**LEGAL ADVERTISEMENT
PORTLAND PLANNING BOARD MEETING**

- ii. Level III Site Plan and Subdivision; 502 Stevens Avenue; Mixed Use Building; Denis Lachman, Applicant. (5:30 – 6:30 p.m. estimated time) The Board will consider a mixed use building replacing a single family home at 502 Stevens Avenue. The ground floor would have commercial uses and a total of four (4) residential units are proposed on the 2nd and 3rd floors. A shared driveway with parking for 10 vehicles is proposed on the lot. The site is in the B-1b zone.

To: Chair Boepple and Members of the Portland Planning Board

● DANGEROUS SPOTS FOR PEDESTRIANS

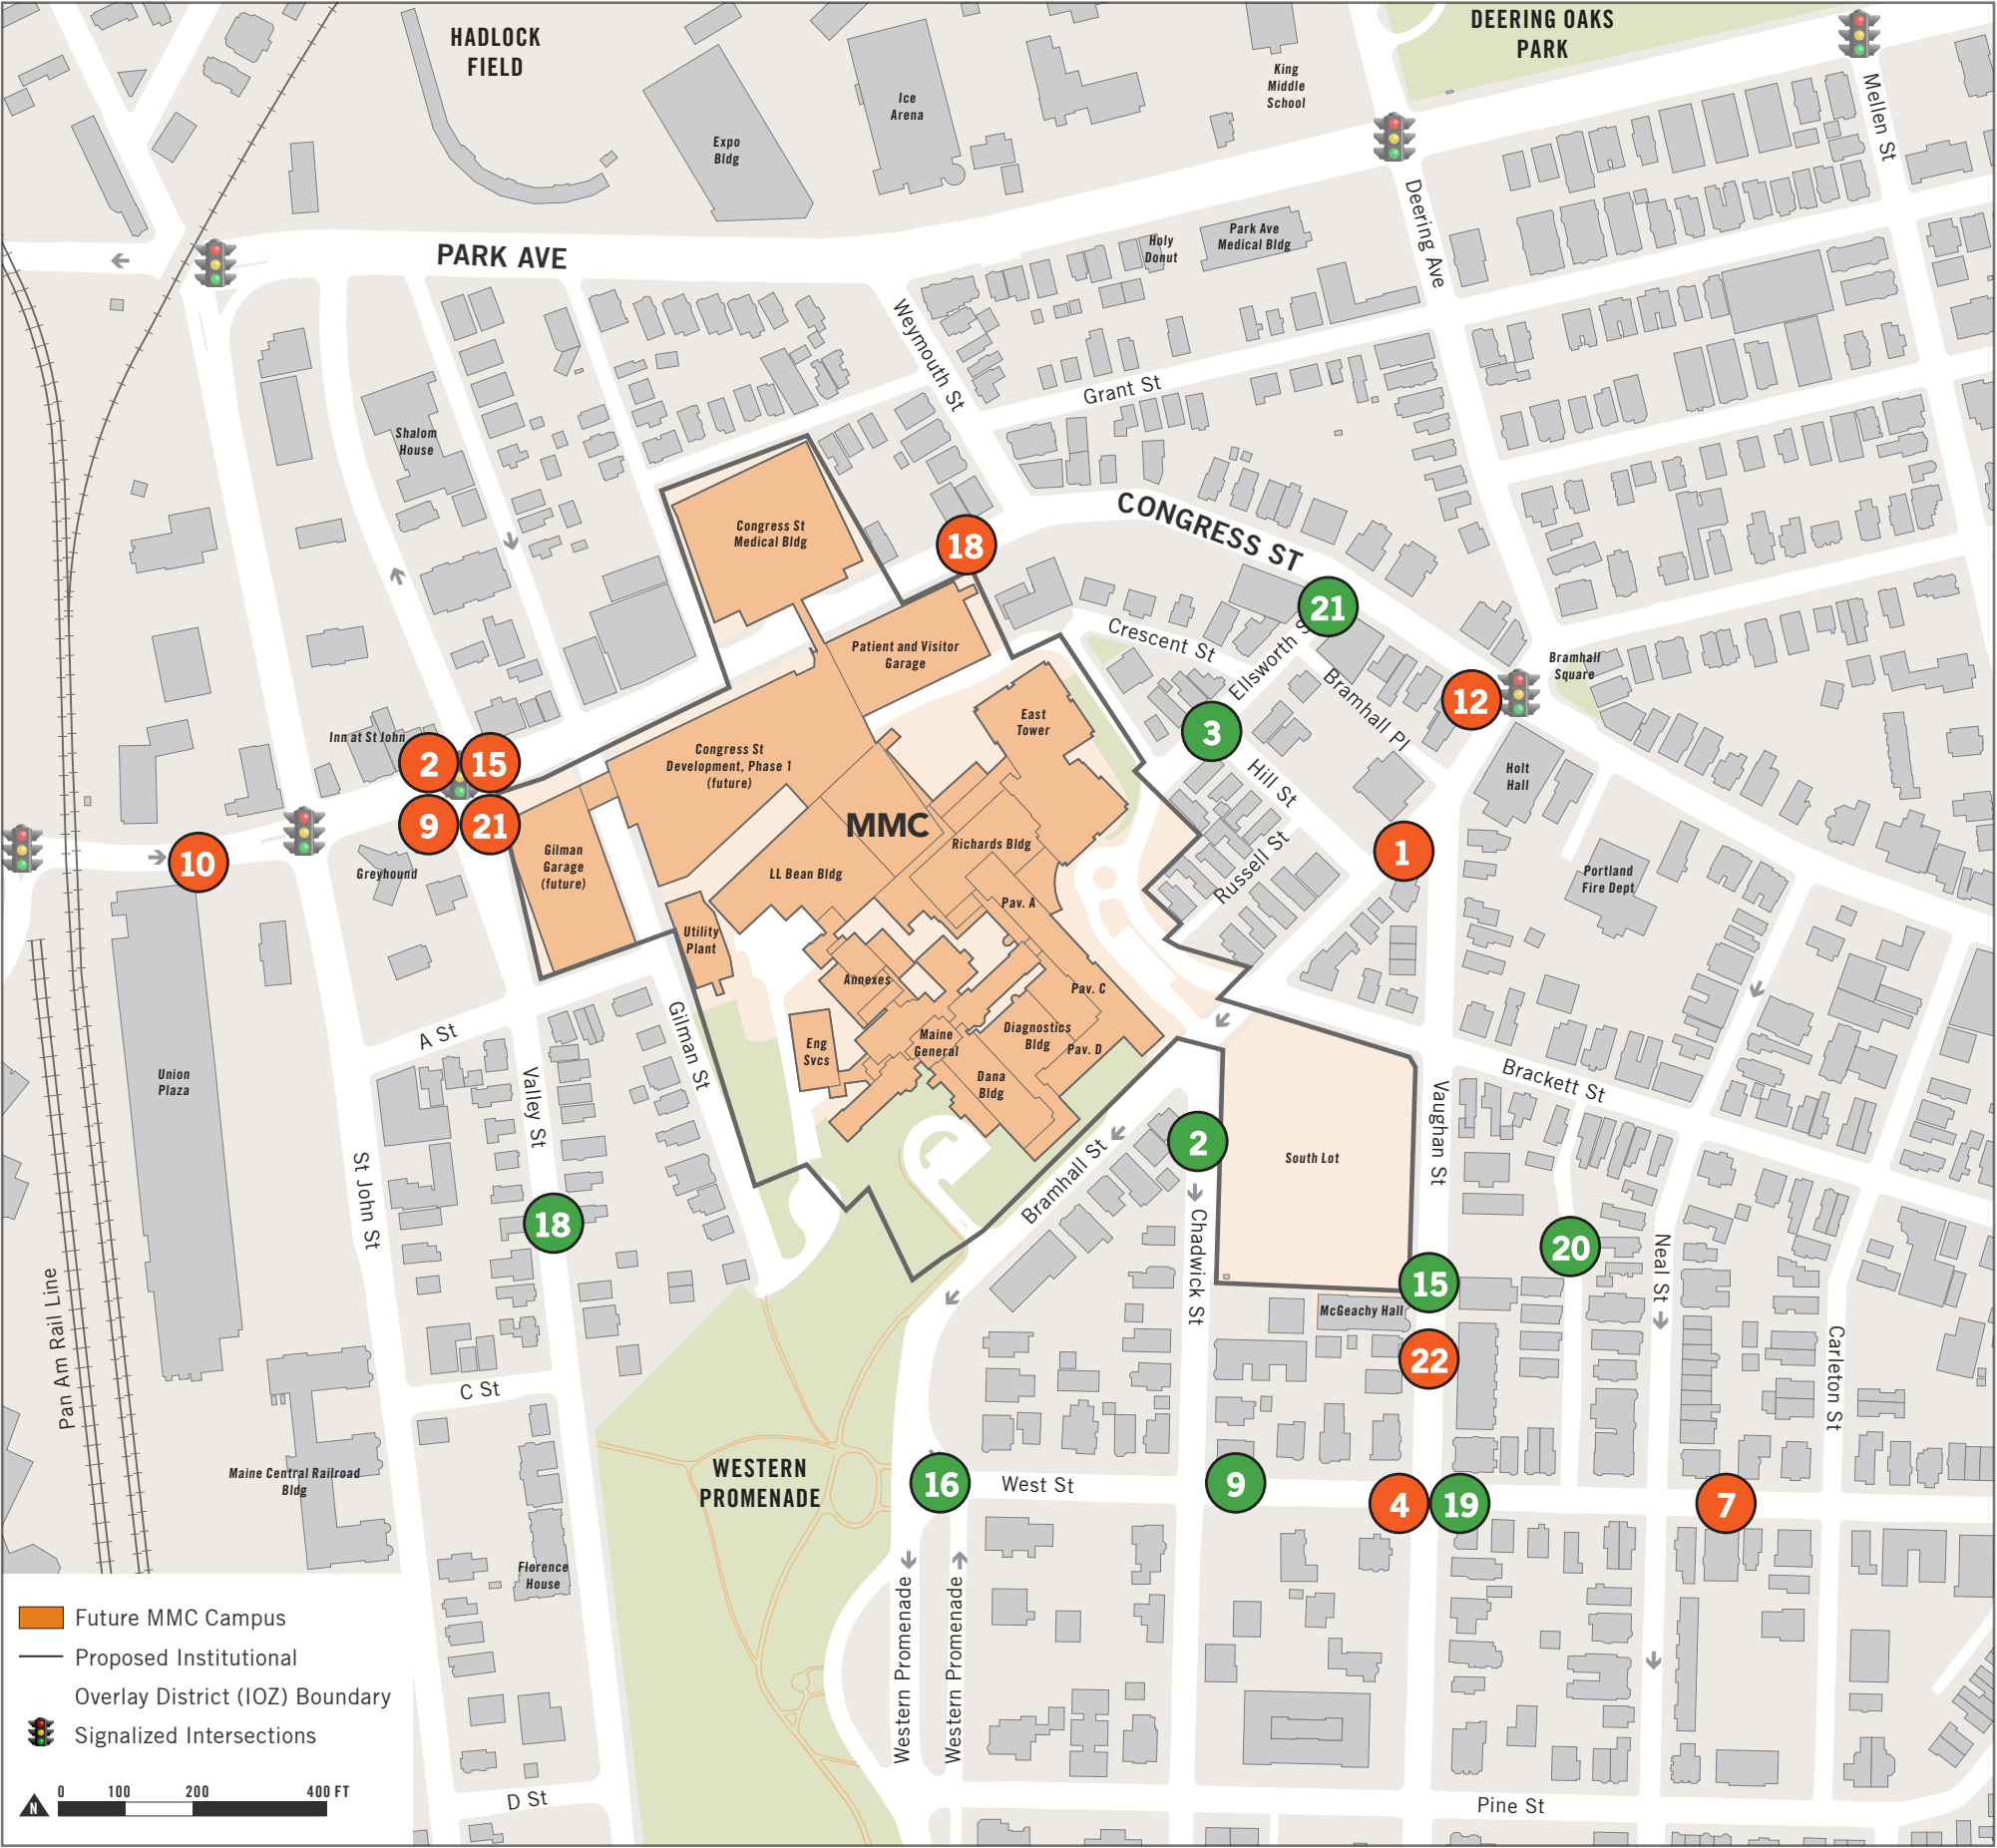
- 2. Cars fly down Chadwick to West and many don't bother to stop at the stop sign.
- 7. MMC traffic often blows through stop sign at top of Chadwick at West Street and treats West between Chadwick and Vaughan as one way. Very dangerous!! They are often confused and distracted. (Drew Anderson, 92 West St.)
- 8. I can see the intersection of West/Chadwick from my house. We witness a traffic infraction at that intersection about every 15 minutes.
- 10. Need street level pedestrian crossing.
- 11. Hard to cross, especially @ Congress and Weymouth (Emma Pope-Welch, 12 Boynton St)
- 12. Known risky intersection for cars, bikes, pedestrians
- 13. Hard to cross, especially @ Congress and Weymouth (Emma Pope-Welch, 12 Boynton St)

● CONGESTED ROUTES

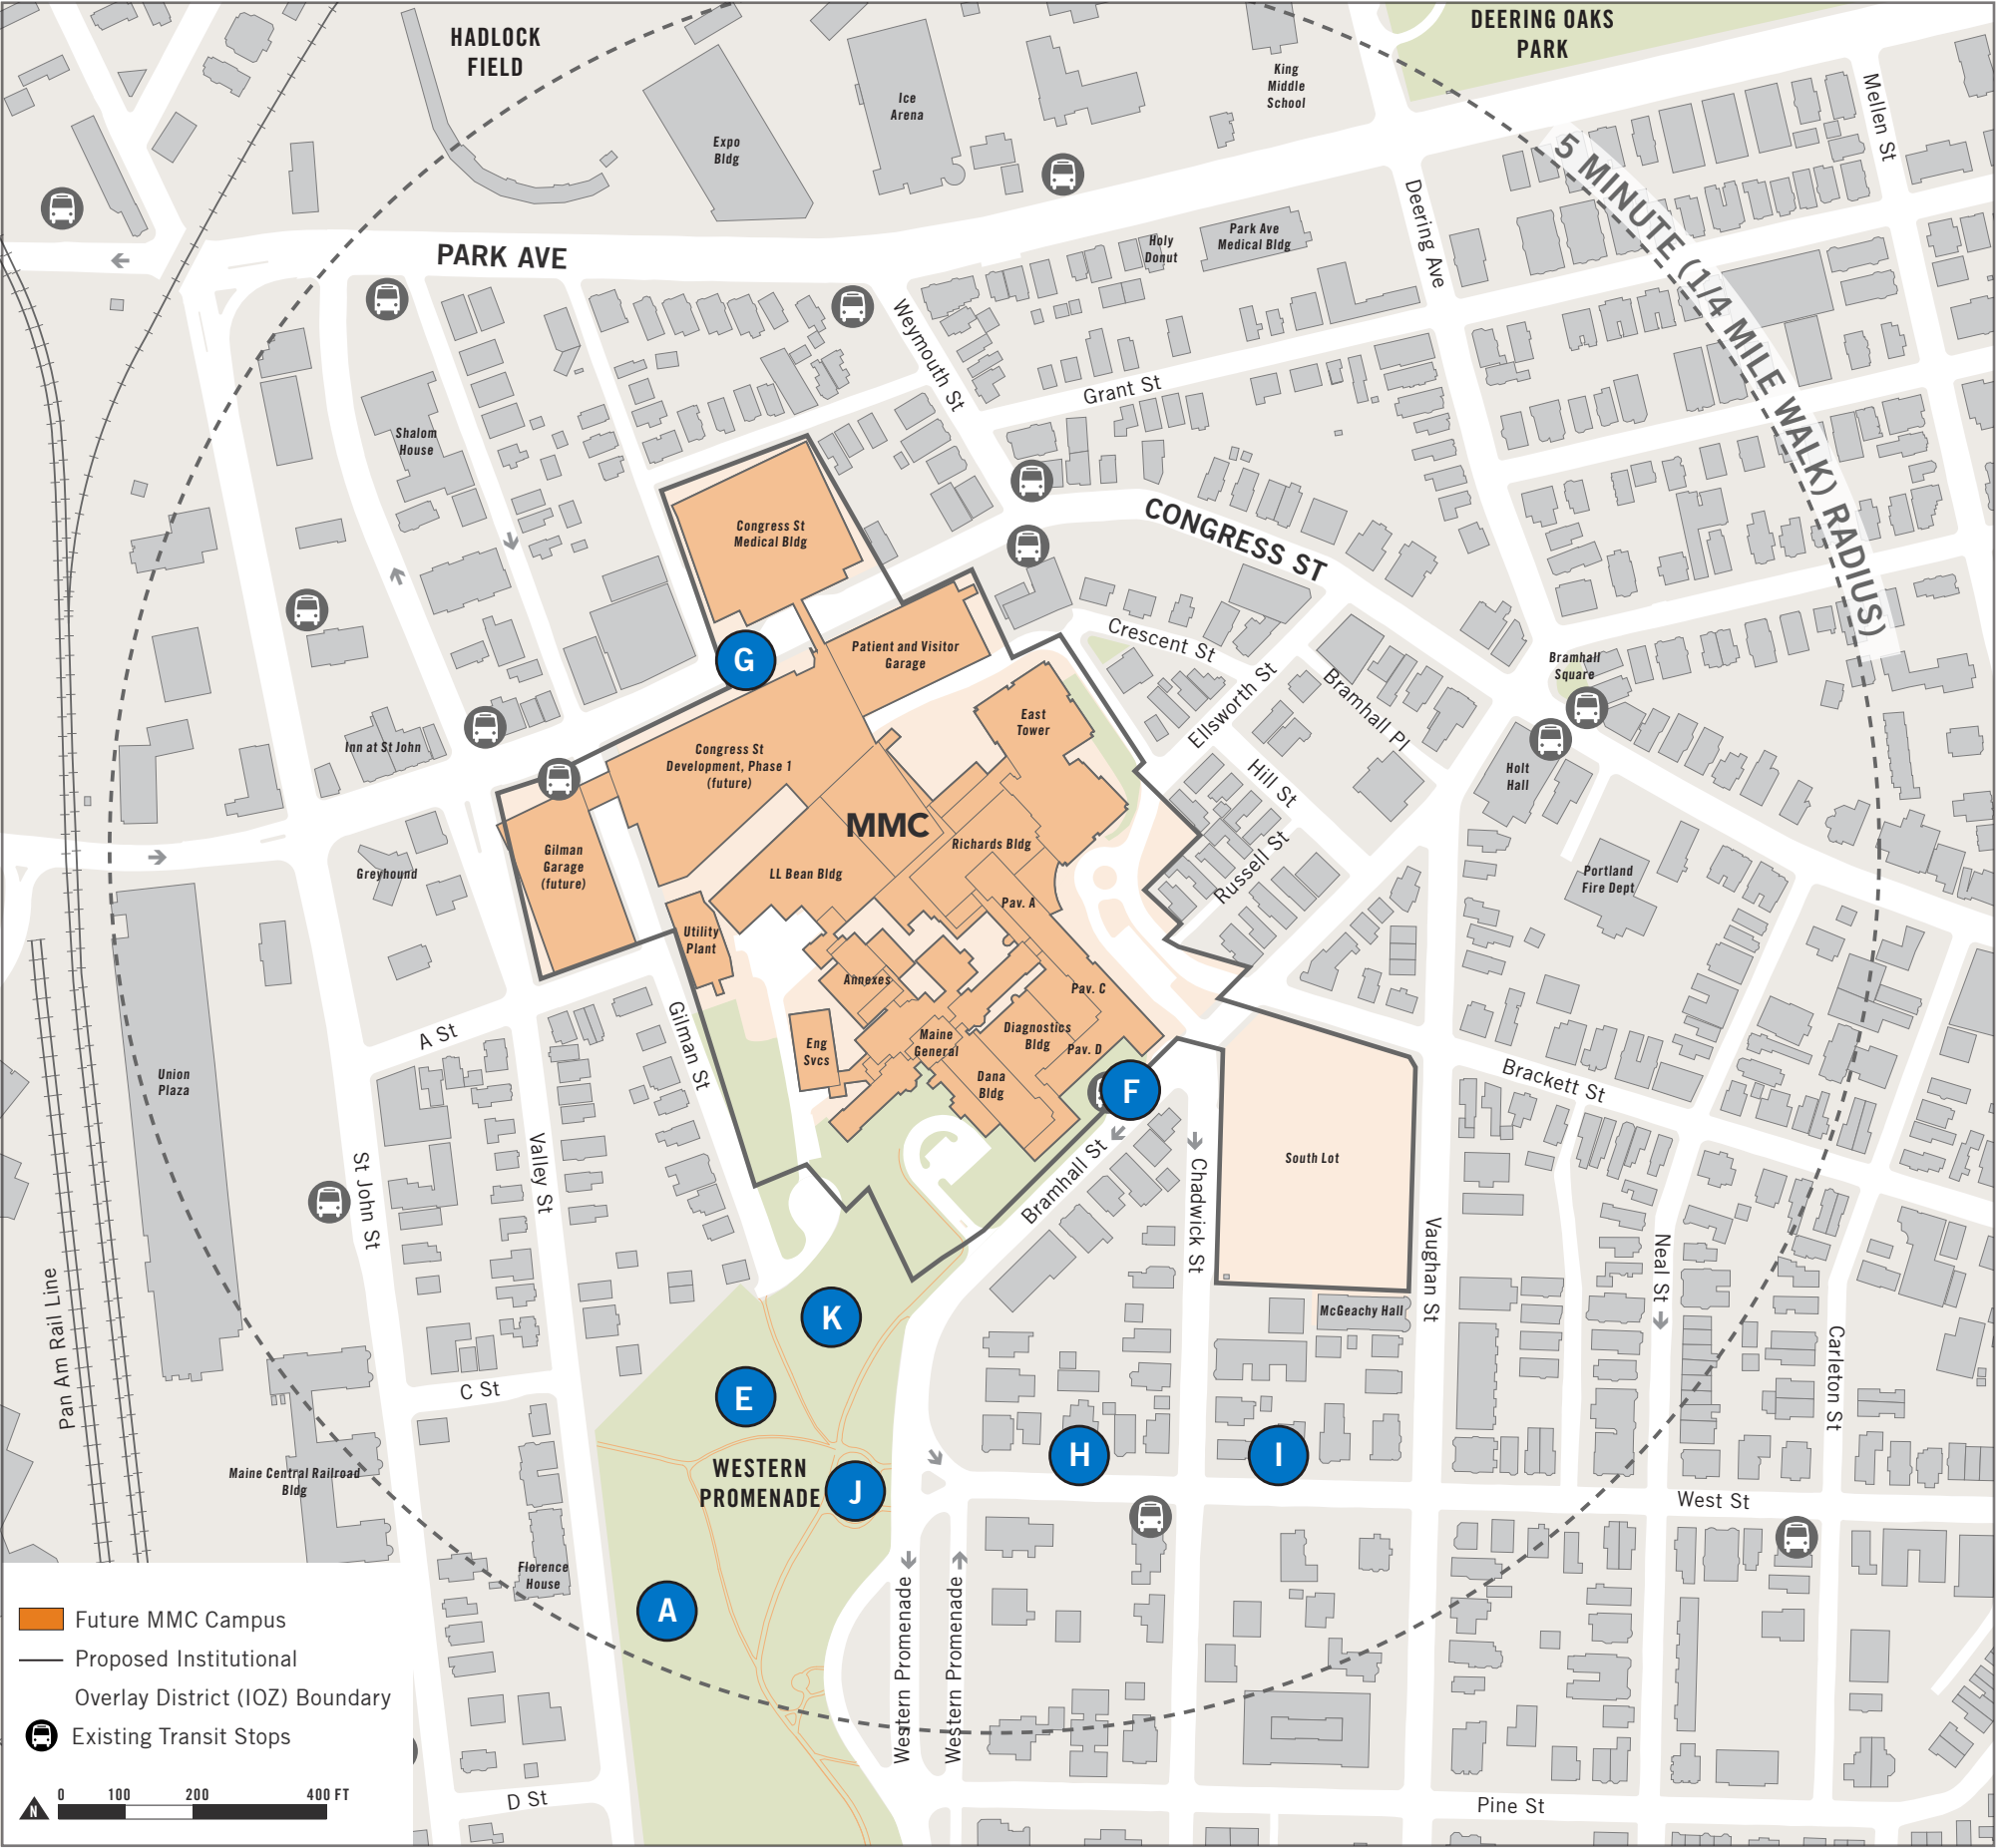
1. Traffic can build up at Bramhall hill headed toward Congress from Bramhill, and MMC visitors often miss the stop sign and fly through. (Randy Dee Ferrell, 7 Russell St.)
10. Right turn exit from Union Station (into 3 lanes of traffic) is extremely challenging.
12. I use Ellsworth as a cut through when traveling west on Congress to avoid right turns at light at Bramhall and Congress.

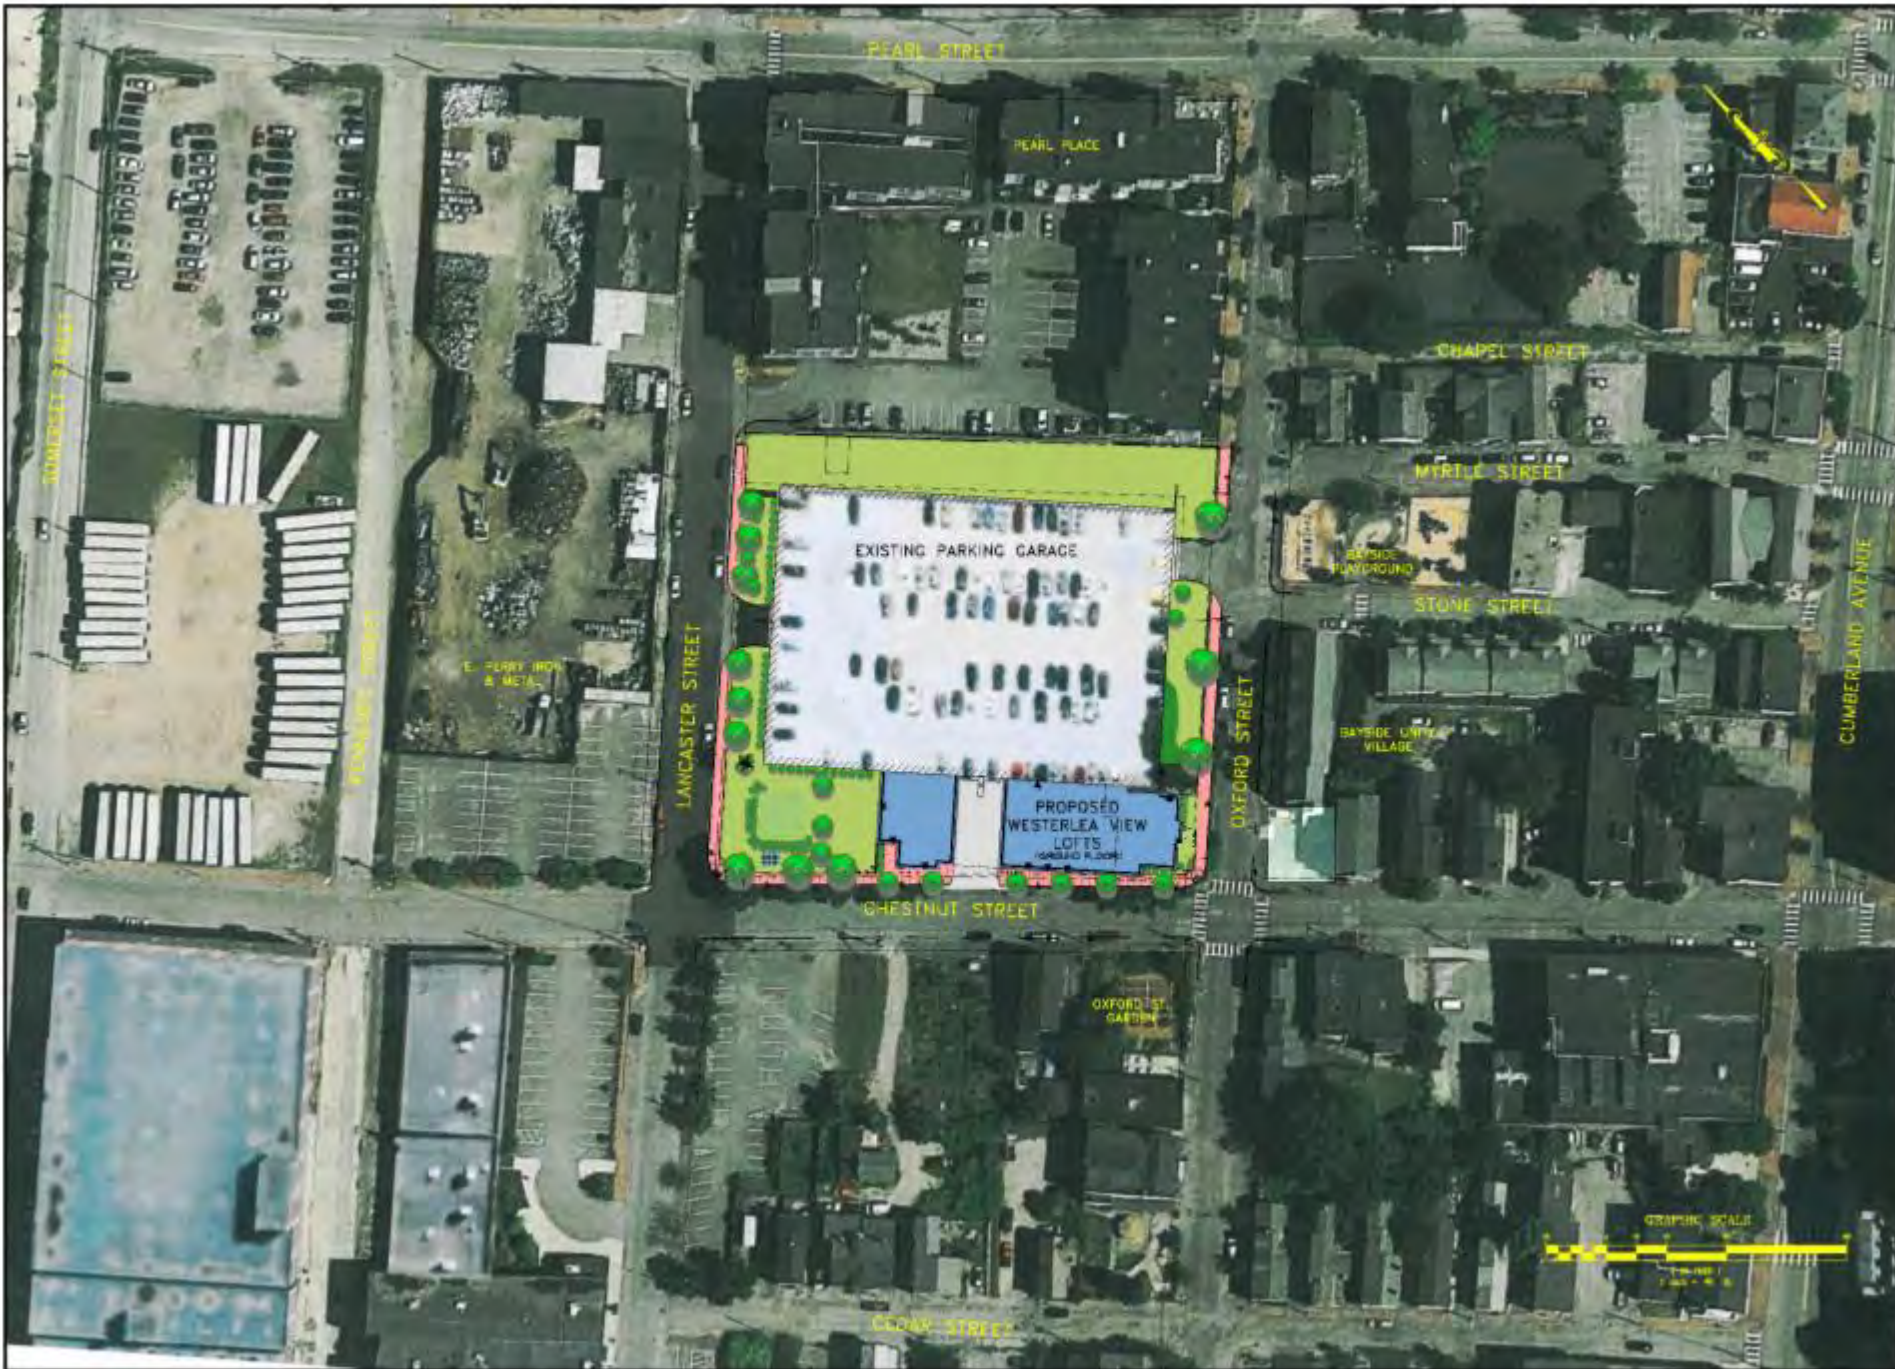
- The project uses fenestration at the ground levels, entrances emphasize with canopies and material change, recessed bays at the upper floors, and open space at the end of the block.

- The level of detail and articulation on the Chestnut Street elevation is not sufficient, especially at the street level. Material changes are mostly arbitrary and other than at the entrance, do not correspond to uses or plane changes. Revisions to meet this standard could come in form of enclosure; articulation and detail (reveals, dimensional trim, material transitions, detail); placement of material that corresponds with uses.
